City Staff Recommended Responses to Requested Modifications

DSP-19050

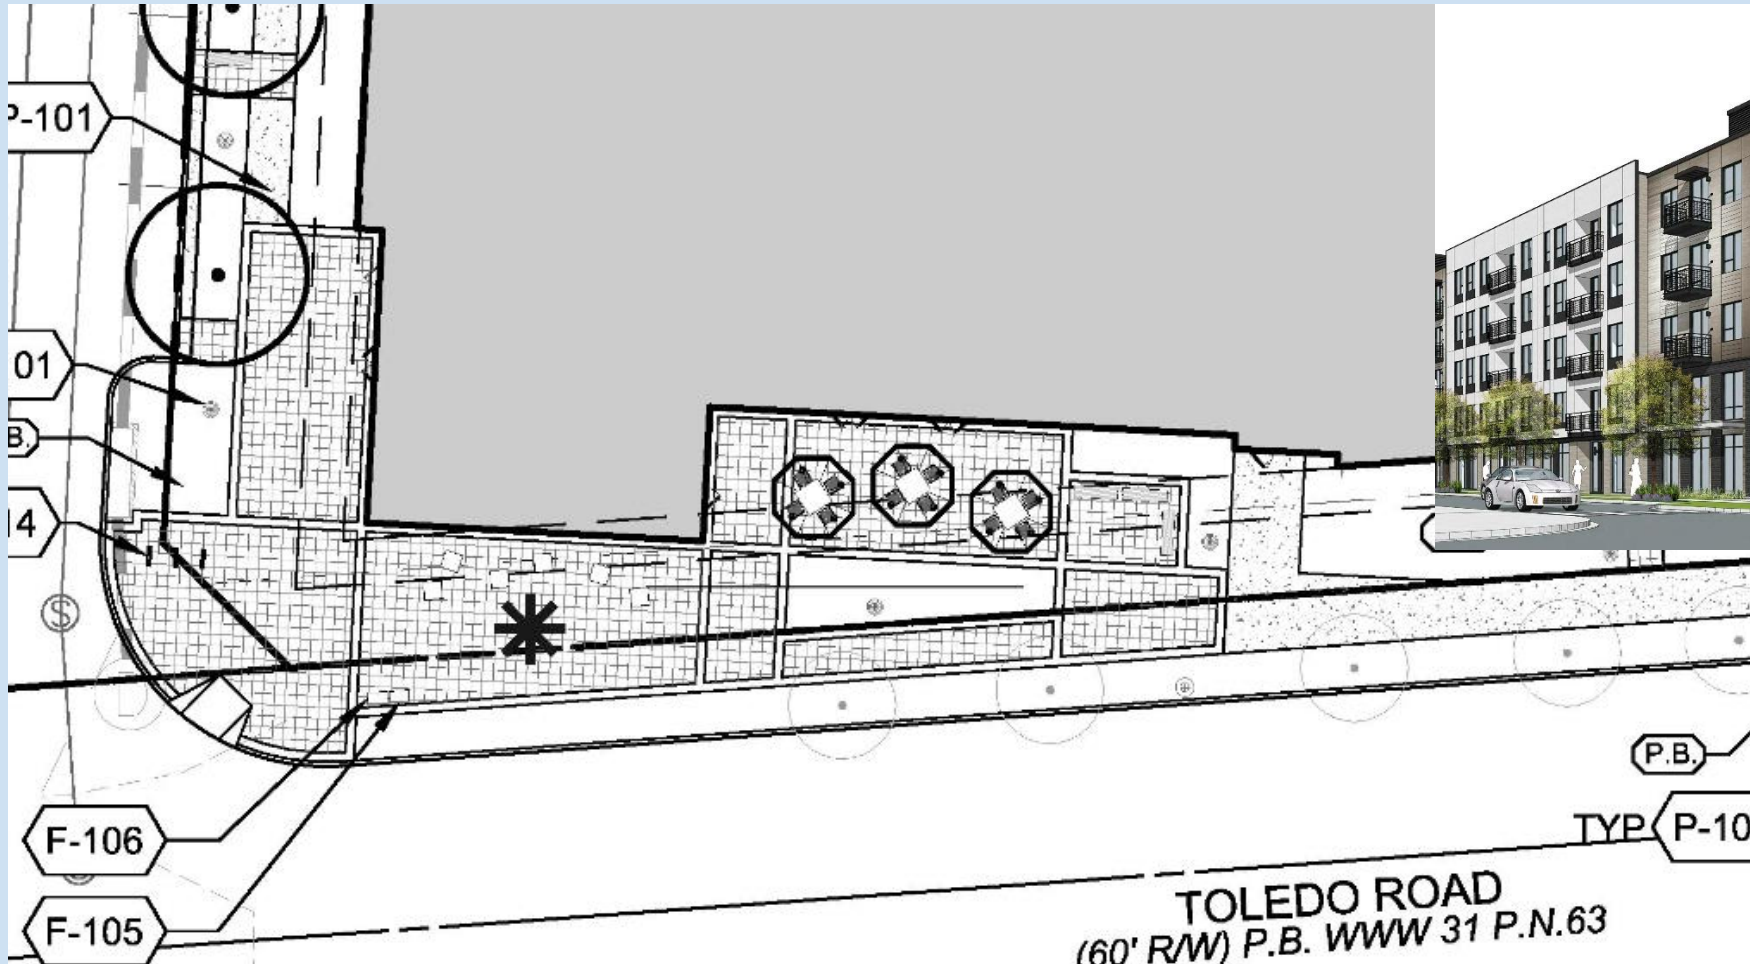
#2 City Staff recommends all transformers associated with this development be installed subgrade.

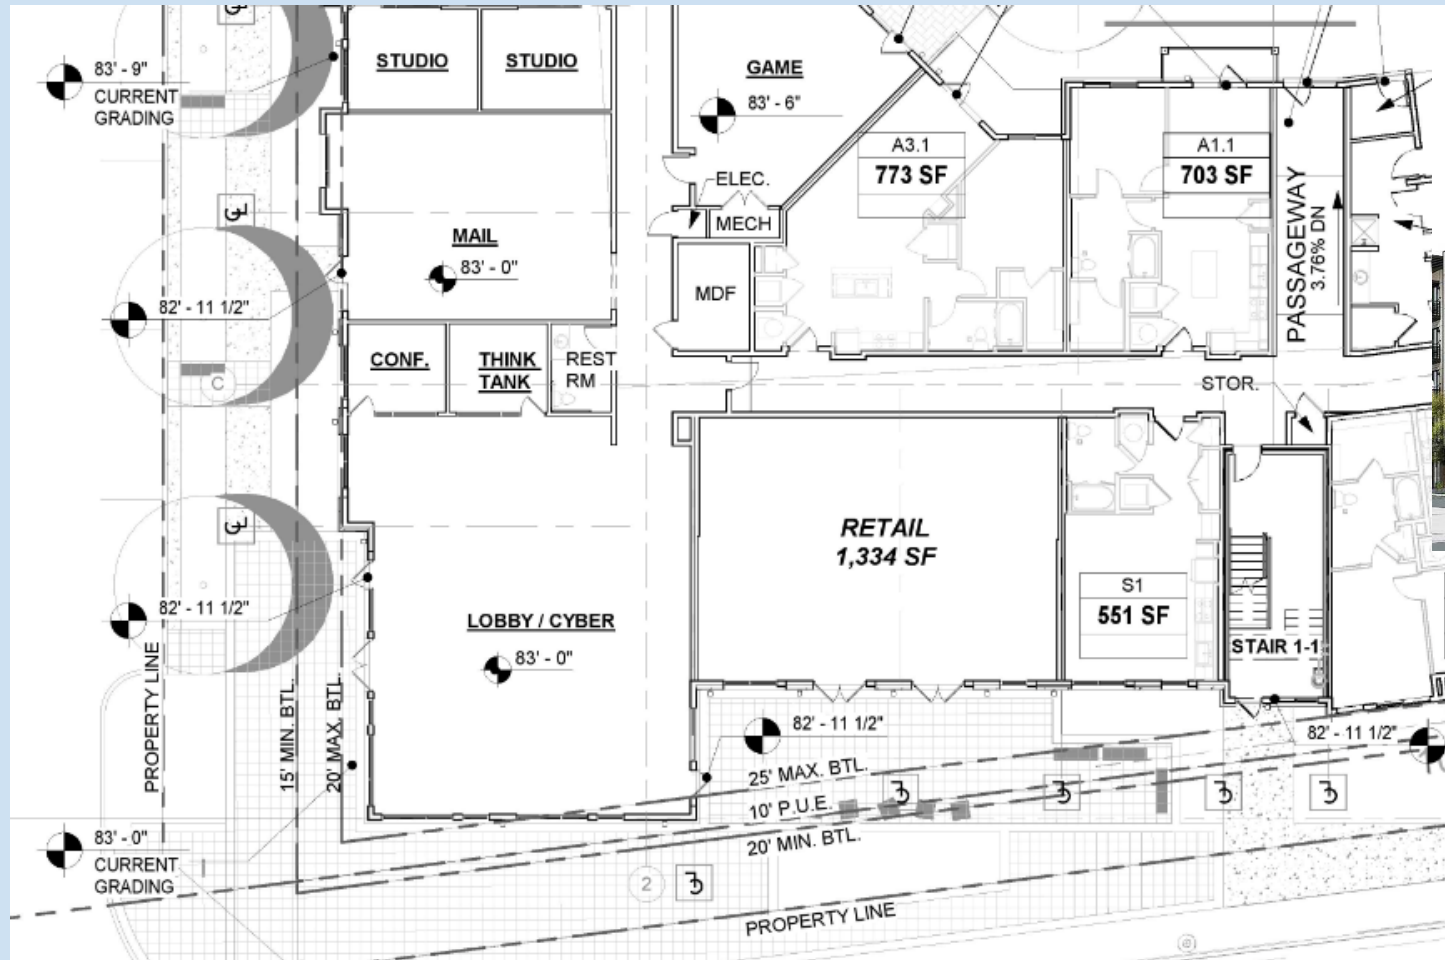
#7 Requesting an extension from the required build-to line for the proposed retail space.

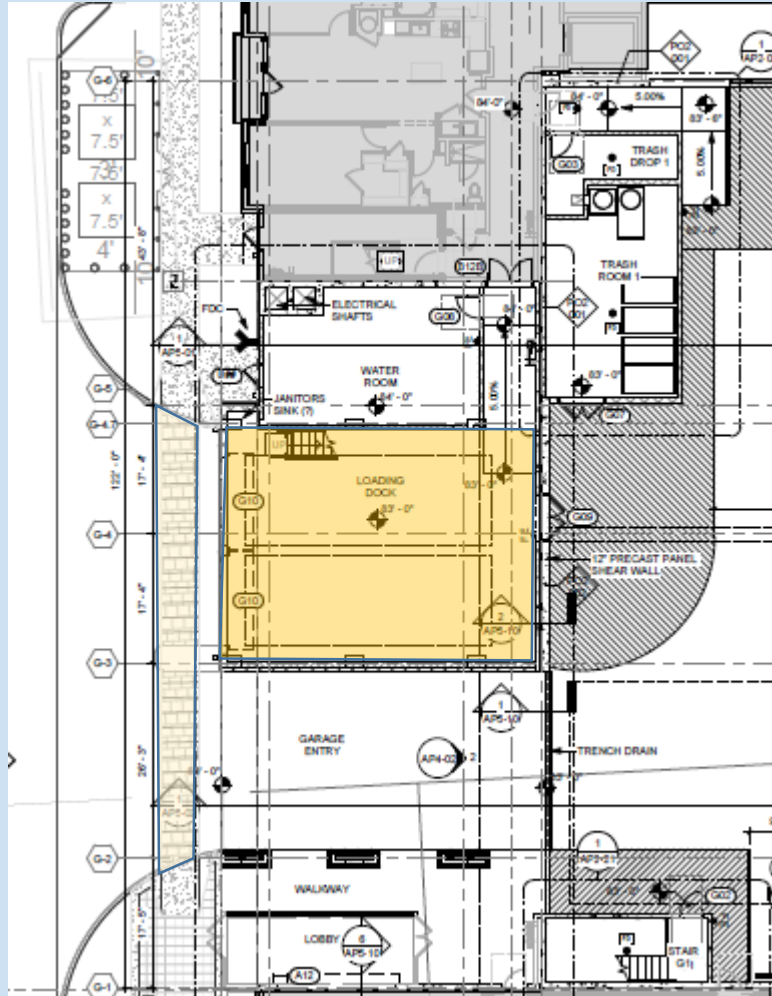
#9 Requesting the entrance of the apartment building front Public Road B as opposed to an "A" Street (Toledo Road).

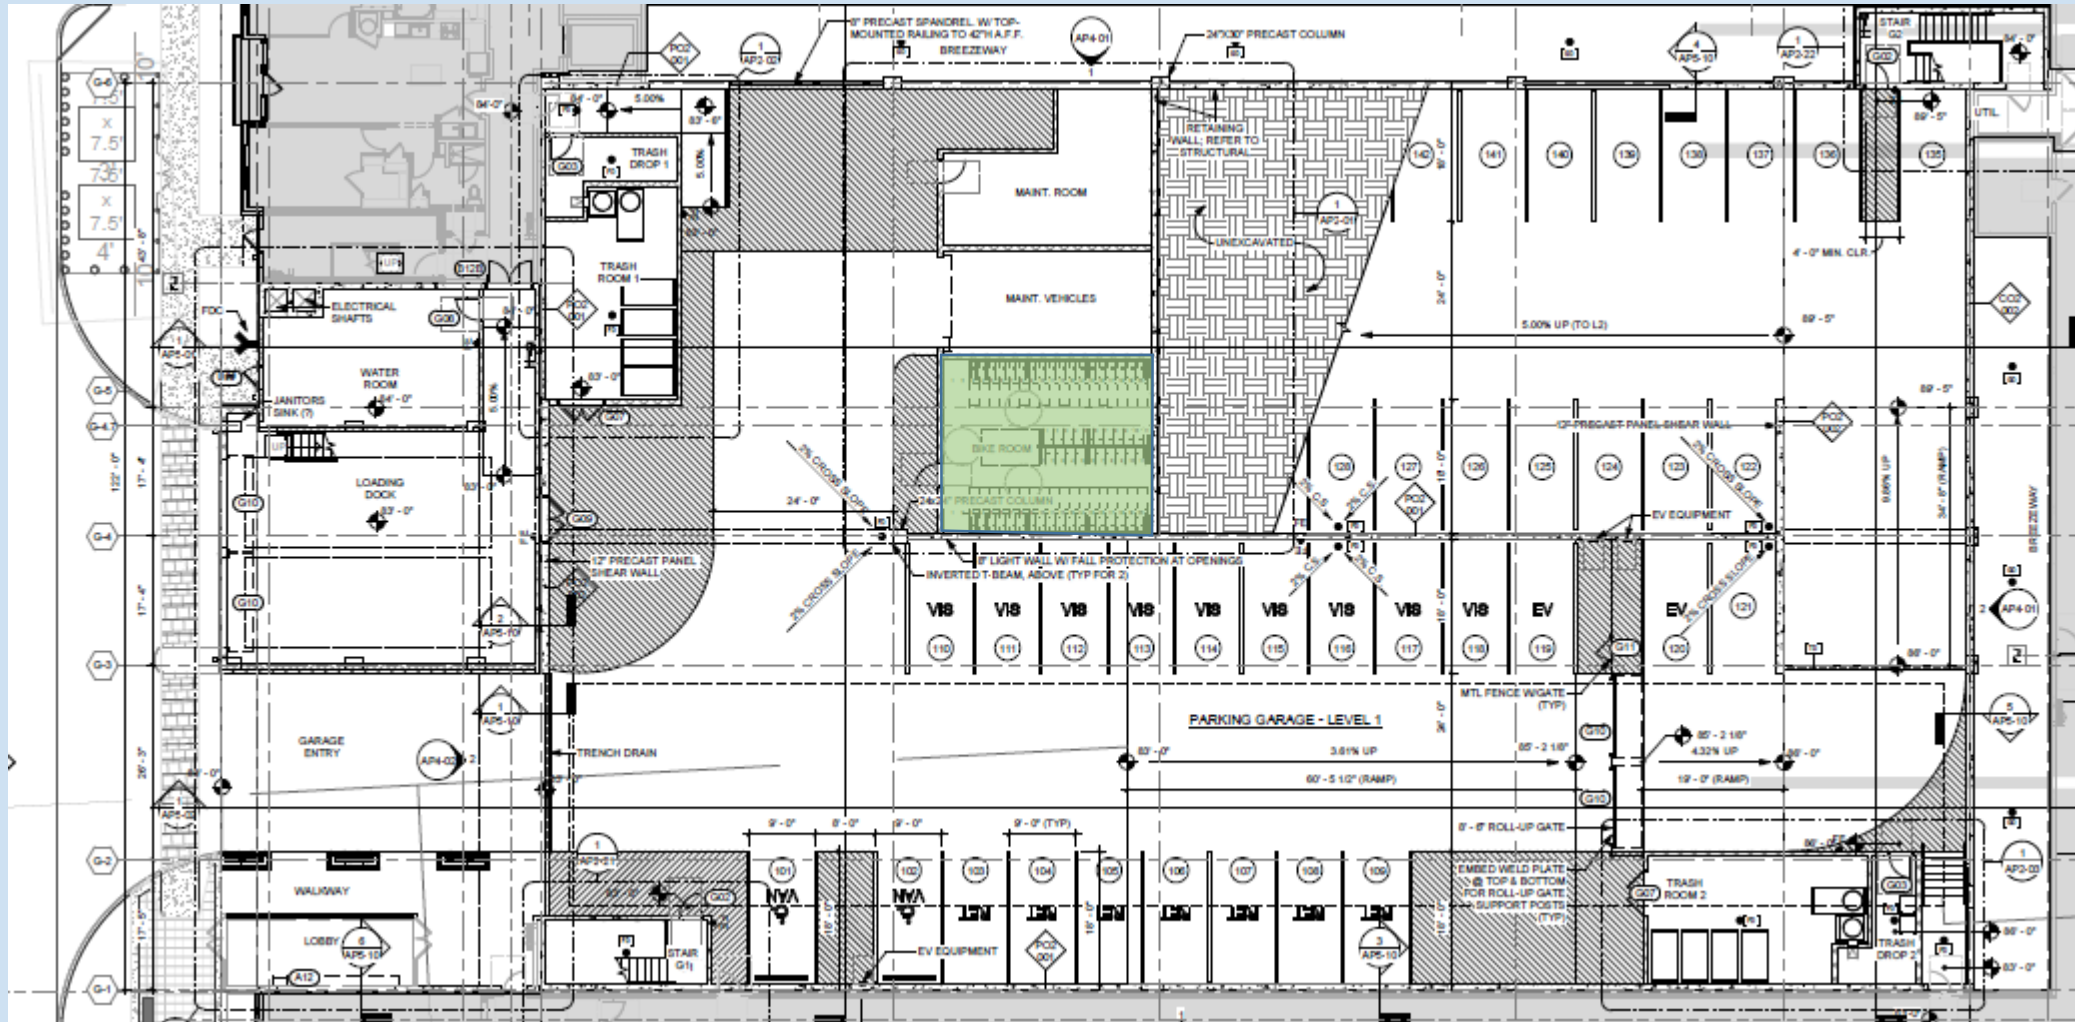
#1 City Staff recommends the establishment of a dedicated delivery and service area within the proposed garage rather than have vehicles utilize Public Road B for deliveries.

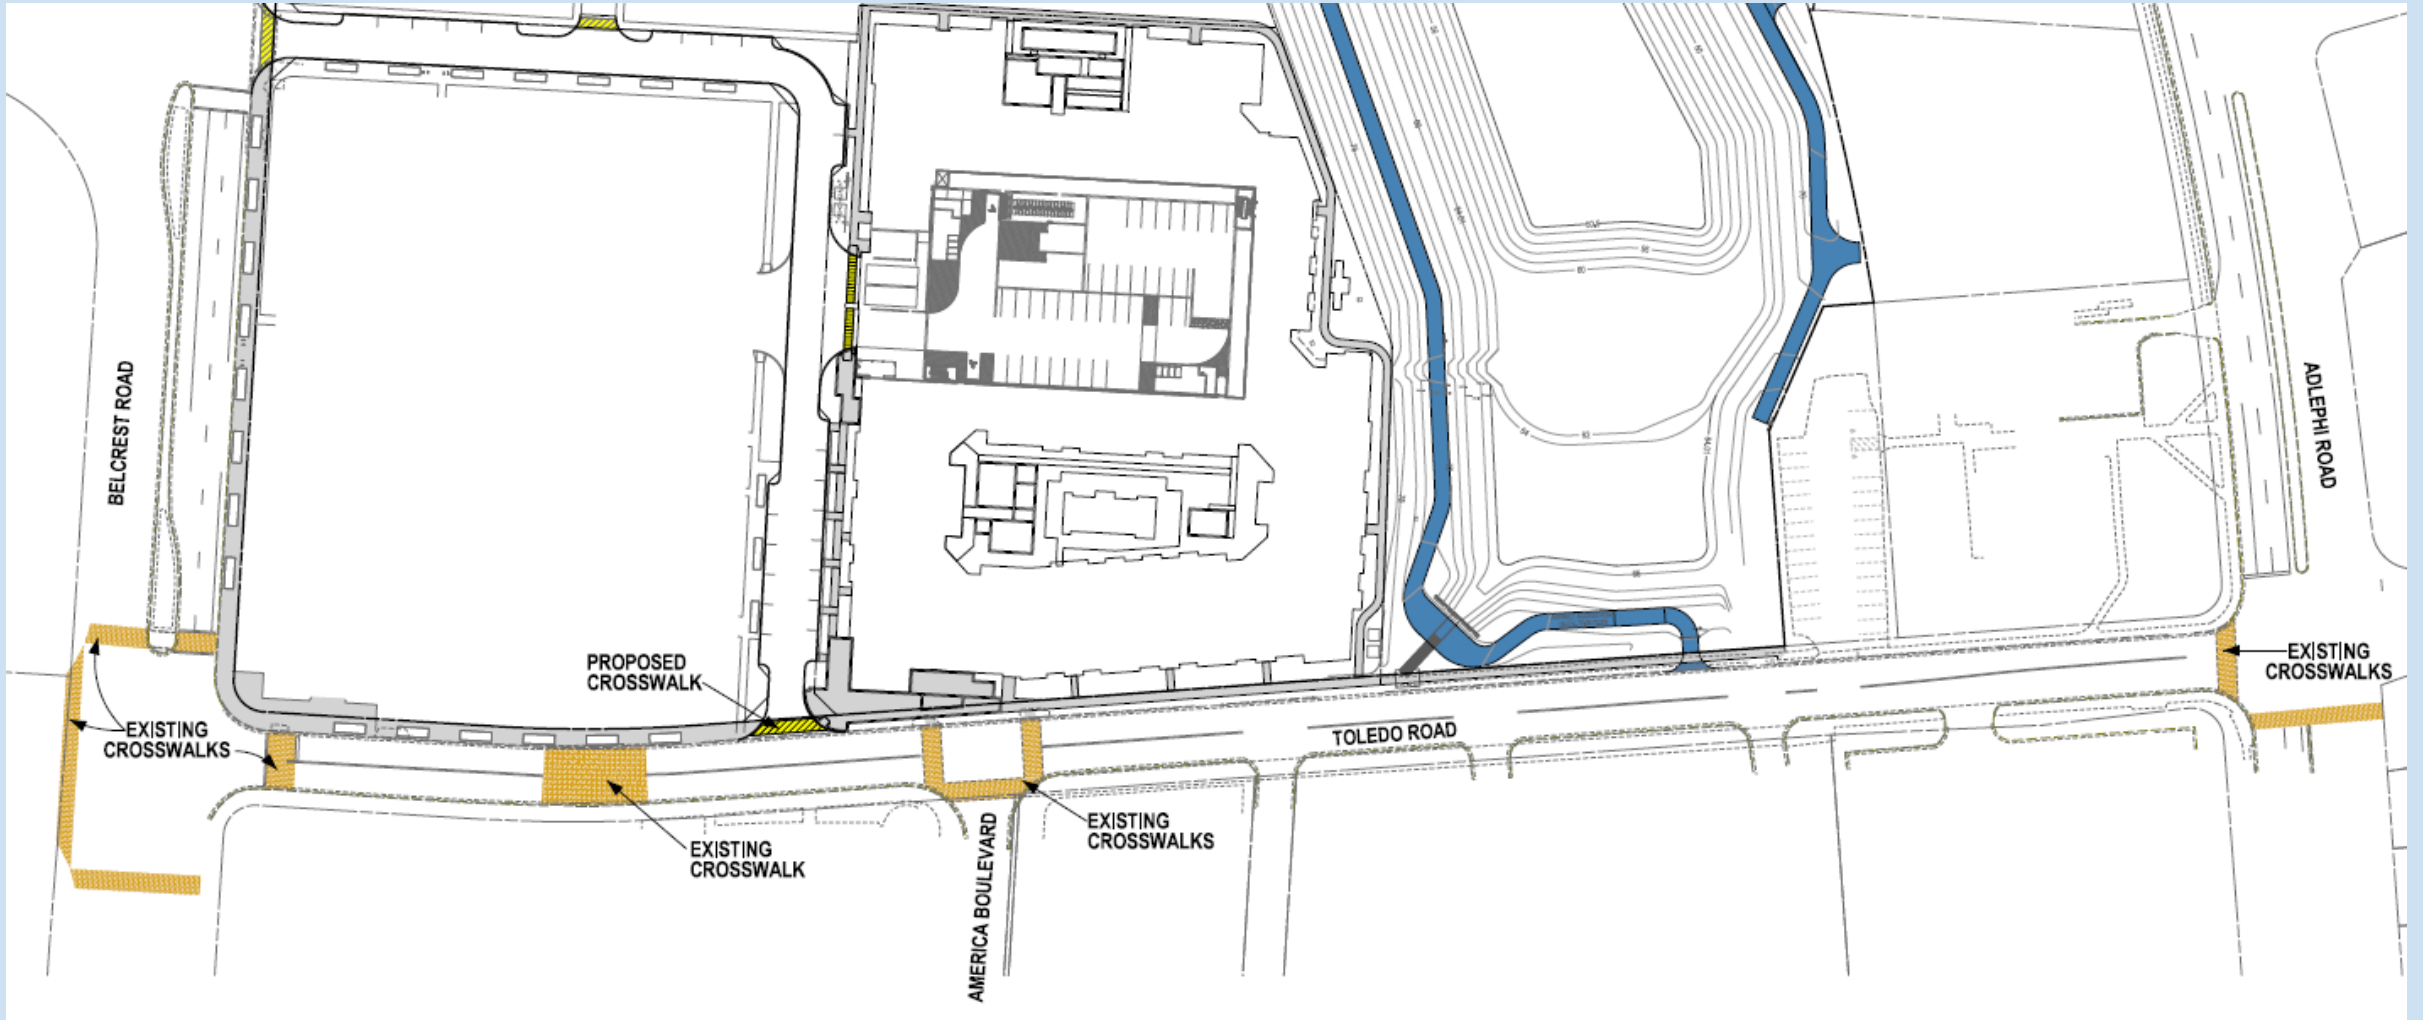
#2 To ensure the building has adequate bicycle parking capacity for its residents, City Staff recommends a 1:1 ratio of bicycle parking spaces to vehicle parking spaces.
